PLANNING & ZONING COMMISSION COMMUNICATION

AGENDA ITEM: Discuss and make a recommendation regarding a Final Plat for a 32.029-acre

property situated in the J. Burke Survey, Abstract Number 42, in the Town of Bartonville, Denton County, Texas. The property is located near the southeastern corner of Broome Road and Porter Road, in Bartonville, Texas. The applicant is McAdams, Inc., on behalf of Philip R. and Martha S. Rice. [Town of Bartonville File

Number FP-2025-002.]

FILENAME REPLAT 2.0

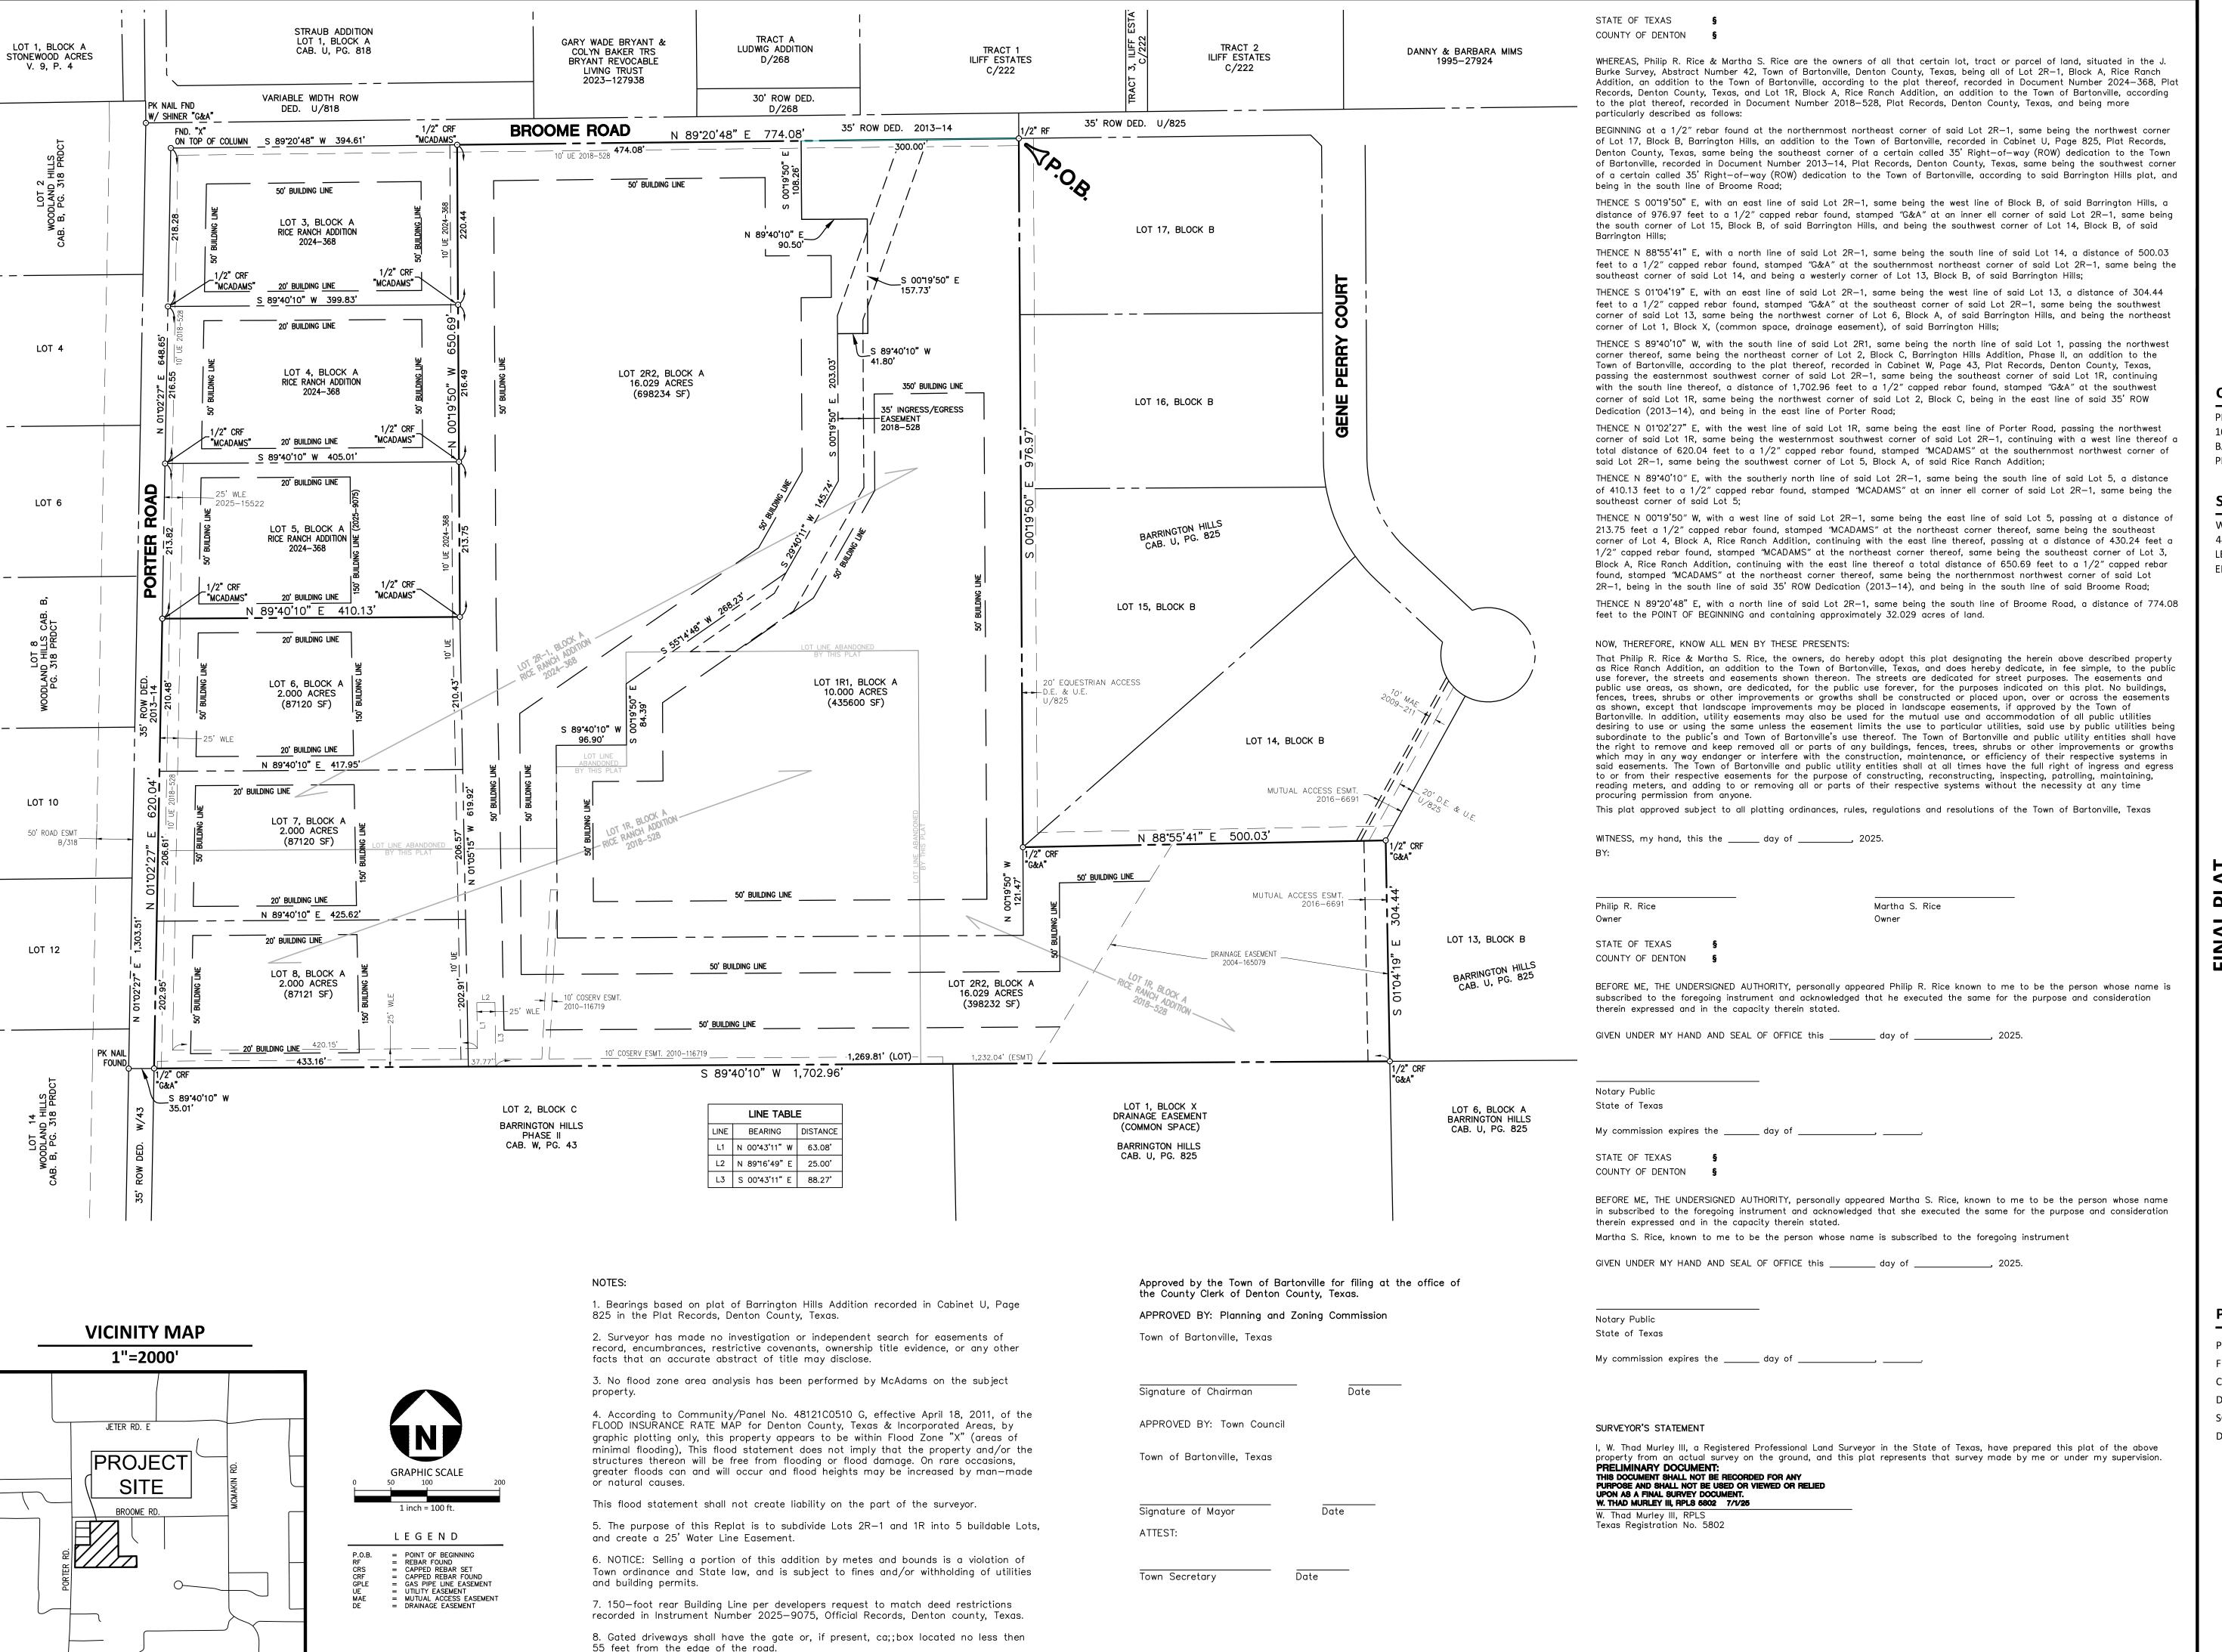
The submitted final plat is designed to create five legal lots totaling 32.029 acres. The resulting lots will range from 2.00 to 16.029 acres. The submitted final plat conforms to the approved preliminary plat, adjusted as needed to respond to conditions of approval. The final plat addresses the following Town Council conditions from the preliminary plat approval:

- a. This condition shall remain.
- 2. Prior to approval of the final plat, all setbacks for Lots 1R1 and 2R2, Block A shall be 50 feet.
 - Addressed.
- 3. Prior to approval of the final plat, the Broome Road street frontage width for Lot 1R1, Block A shall be increased to no less than 300 feet.

- a. Addressed.
- 4. Prior to approval of the final plat, the shared lot line between Lots 1R1 and 2R2, Block A shall be adjusted to avoid creation of any nonconformities between existing structures and dimensional standards as they apply to the new lots.

- a. Addressed.
- 5. Minor correction: The setback label for Lot 8, Block A shall read "50' setback line" or be adjusted to be 20 feet from Lot 2, Block C, Barrington Hills Phase II.

- a. Addressed.
- 6. Gated driveways shall have the gate or, if present, callbox, located no less than 55 feet from the edge of the Broome Road or Porter Road rights-of-way.

- a. Addressed via final plat per Note 8.

- 1. Prior to recordation of the final plat, the plat and accompanying planning materials shall be reviewed and approved by the registered sanitarian for the Town of Bartonville, in accordance with Title 30, Texas Administrative Code, Chapter 285, Section 285.4(c). Basis: Town Code Chapter 10, Exhibit A, Development Ordinance Section 2.6.e.4.
- 2. Prior to recordation of the final plat, the 25' water line easement (WLE) shall be labeled "25' WLE (BY THIS PLAT)". Basis: Town Code Chapter 10, Exhibit A, Development Ordinance Section 3.3.e.

- 3. Prior to the recordation of the final plat, the "30' GPLE 2010-86118" located within proposed Lot 6, Block A as shown in the approved Rice Ranch Minor Plat (MP-2024-003) shall be shown on the plat, unless documentation of the easement's vacation is provided to the Town. Basis: Scrivener's correction
- 4. Prior to recordation, the 25' WLE to be established by the plat shall be located to the east of the 30' GPLE along Porter Road. The water and gas line easement cannot overlap in parallel fashion. Basis: Town Code Chapter 10, Exhibit A, Development Ordinance Section 3.3.e.
- 5. Minor Correction: Note 8 shall read, "Gated driveways shall have the gate, or if present, callbox, located no less than 55 feet from the edge of the road." Basis: Scrivener's correction.
